SERVICE BULLETIN

MODEL NAME : Di620
MODEL CODE : 1155
NO. : 009B
DATE : 981001
SUBJECT : CORRECTION OF SERVICE MANUAL

18-7. Mechanism and Control of Fusing Roller Small-Amount Turning

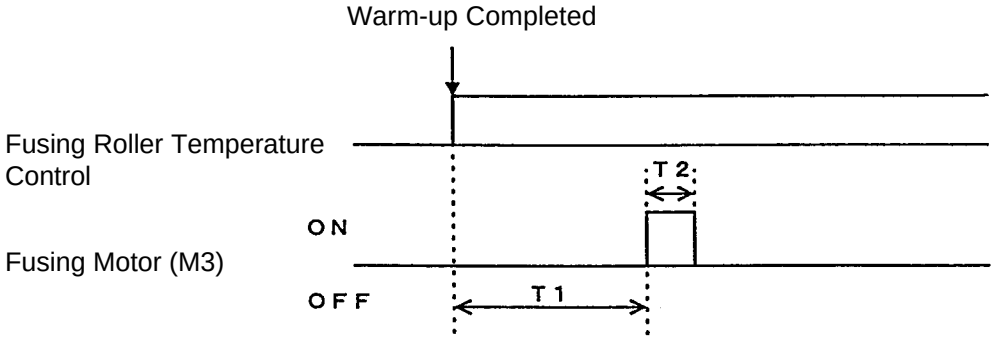
Page: M-121

ADDITION

If the Upper and Lower Fusing Rollers are kept in the temperature-controlled stage for more than a given period of time, the areas of the two rollers in contact with each other are deformed by heat and pressure. To prevent this situation, the rollers are automatically driven for a given period of time to change the areas of the rollers in contact with each other.

T1: 240min T2: 63ms
